INDESIT company

Model type:
ARTXD129EU/HA

Commercial code:
F061078

1260310 Exploded views

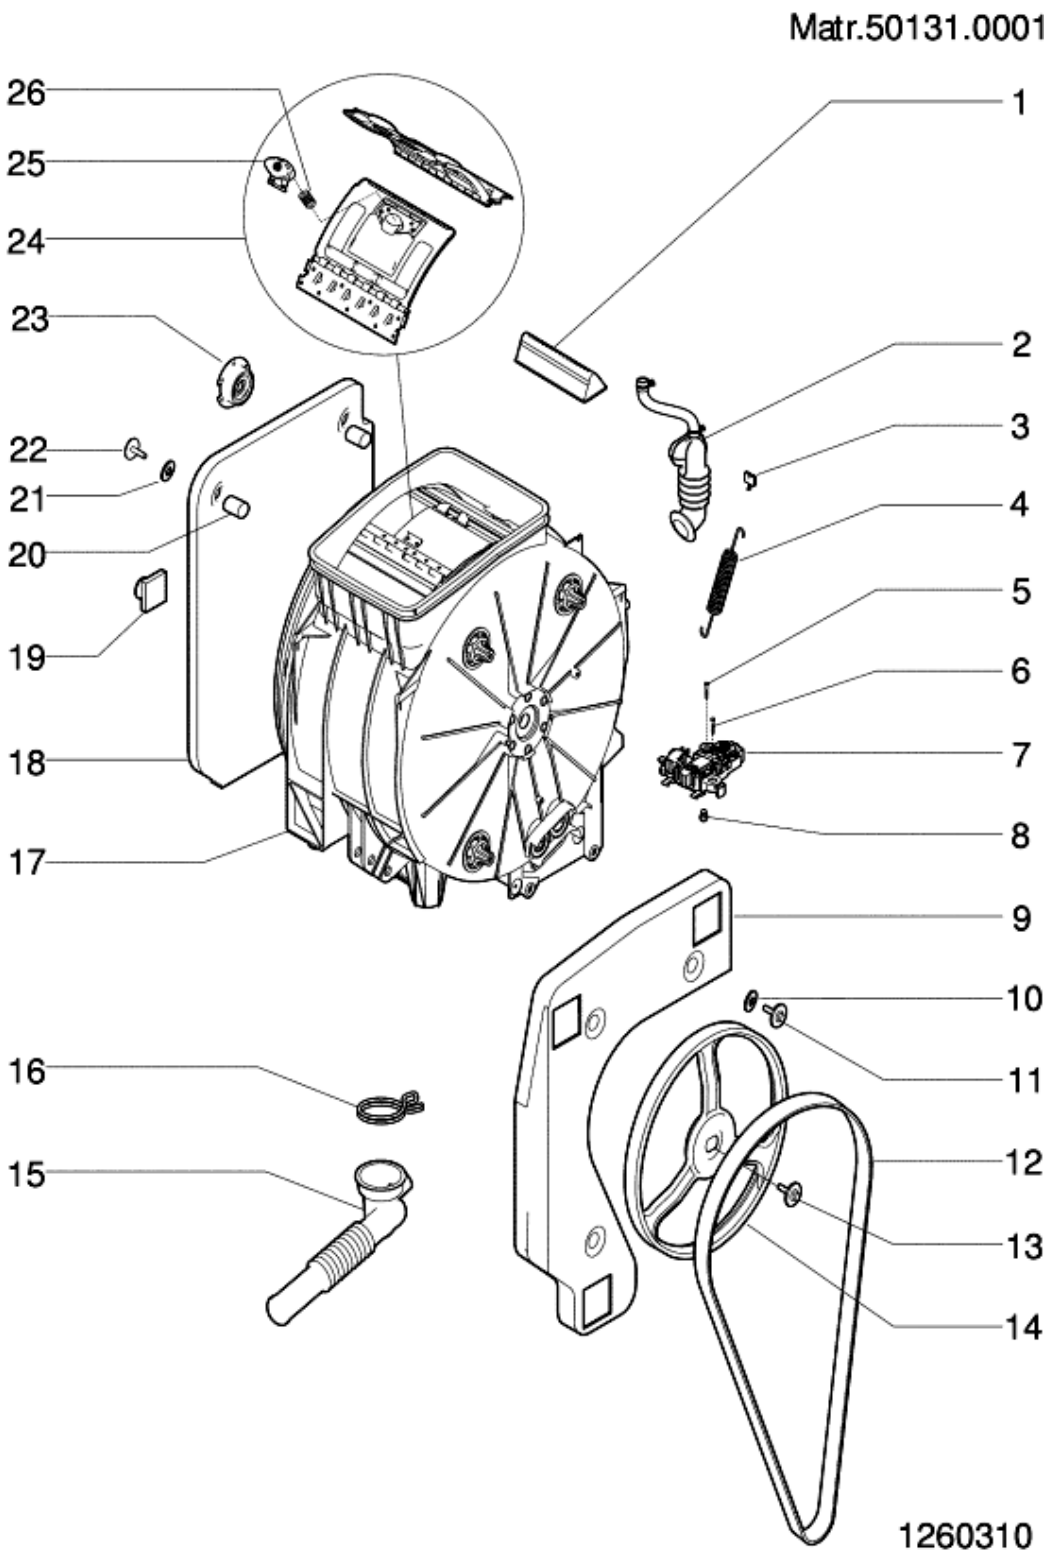
n4009a02: Motor fixing changed on Top Loading washing machines

Top Loading washing machines have changed the fix of motor to the tub.
The tub design is changed in the motor fixing side and two new screws code C00268497 are introduced instead of the old screws C00084333 and the old nut:

C00266015 nut of products with Triphase motor;

C00258673 nut of products with Collector motor.

n4011e13: NEW STEAM EXHAUST HOSE TL INTRODUCED

Spare parts warehouse will go on to manage only the new tubs with the same spare part codes:

C00252343 - Tub 1400 rpm

In assistance on premodification products with the new tubs, you have to fix the motor using the new screws C00268497 instead of the screws and nut that you find in the product.

When the pre-modification items are no longer available, all parts will have to be ordered and replaced.
